CITY COUNCIL AGENDA

August 26, 2024

Application of Ribera Development, LLC on behalf of Westwood Subdivision
for Final Major Subdivision

DATA SHEET FOR WESTWOOD

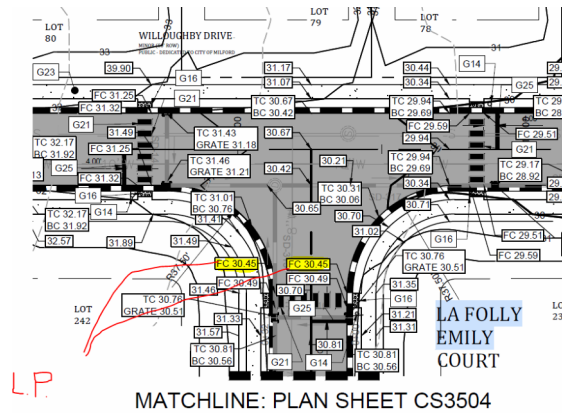
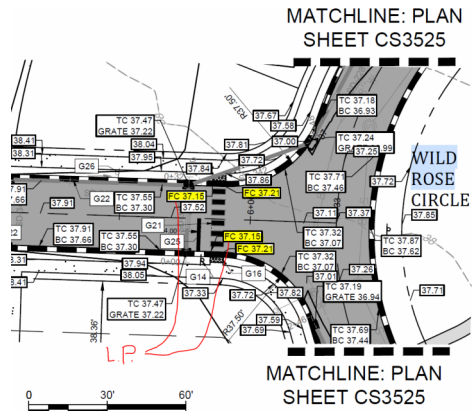
- b) Minimum pipe cover is not being met per the spreadsheet for some pipes. Minimum pipe cover for RCP pipe is 12" from the top of pipe to the top of paving. Minimum pipe cover for HDPE pipe is measured from the top of pipe to

the top of stone under the roadway (do not include the thickness of the asphalt paving). Revise the plans so there is minimum required cover. **Addressed.**
